Access Compliance Report

Public Rights-of-Way

(Curb Ramps)

Intersection ID: 17032	Main Street: QUEENS_RD_WEST	Cross Street: WESTFIELD_RD	Location: W
ADA ID: 4A49C9D0F895	Ramp Type: Perp	Initial Pass/Fail: Fail	Overall Compliance: No
Severity Score: 37.5			
Codes/Mitigation Info/Possible Solution		Field Measurements/Component Compliance

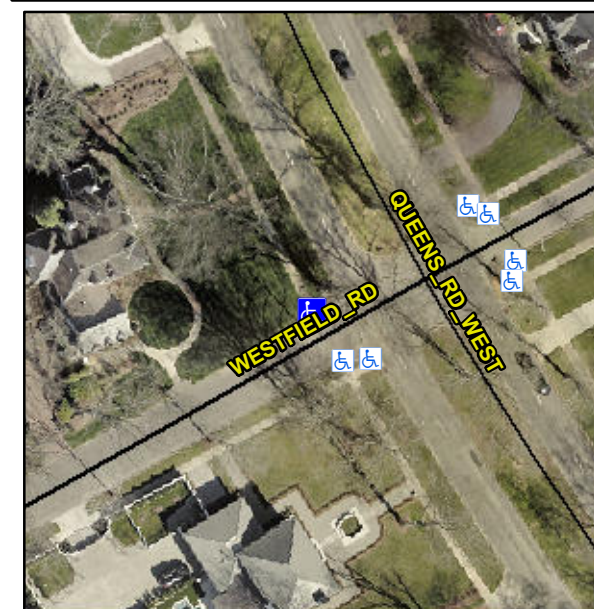
Not Found, R304.2.2, R304.5.3

Compliance	Description	Data	Compliance	Description	Data
N/A	Ramp Length (in)	85.0	No	Ramp Slope (%)	11.3
Yes	Ramp Width (in)	48.0	No	Ramp XSlope (%)	11.9
N/A	Flare Type LT	N/A	N/A	Flare Type RT	N/A
N/A	Flare Slope LT (%)	N/A	N/A	Flare Slope RT (%)	N/A
N/A	Flare Traversable LT?	N/A	N/A	Flare Traversable RT?	N/A
N/A	Landing Length (in)	N/A	N/A	DWS Provided?	N/A
N/A	Landing Width (in)	N/A	N/A	DWS Contrast?	N/A
N/A	Landing Slope (%)	N/A	N/A	DWS Length (in)	N/A
N/A	Landing X Slope (%)	N/A	N/A	DWS Full Width?	N/A
N/A	Landing Curb? (Y/N)	N/A	N/A	DWS Offset (in)	N/A
N/A	Shared Landing?	N/A			
N/A	Gutter Ponding?	Yes	N/A	Gutter Slope (%)	N/A
N/A	Gutter Lip Ht (in)	N/A	N/A	Gutter X Slope (%)	N/A
N/A	Painted X Walk1?	No	N/A	Painted X Walk2?	N/A
	X Walk 1 Direction	To SE		X Walk 2 Direction	N/A
N/A	X Walk 1 Width (in)	N/A	N/A	X Walk 2 Width (in)	N/A
	X Walk 1 Slope (%)	2.6		X Walk 2 Slope (%)	N/A
	X Walk 1 X Slope (%)	2.3		X Walk 2 X Slope (%)	N/A

Remove & Replace Entire Ramp.
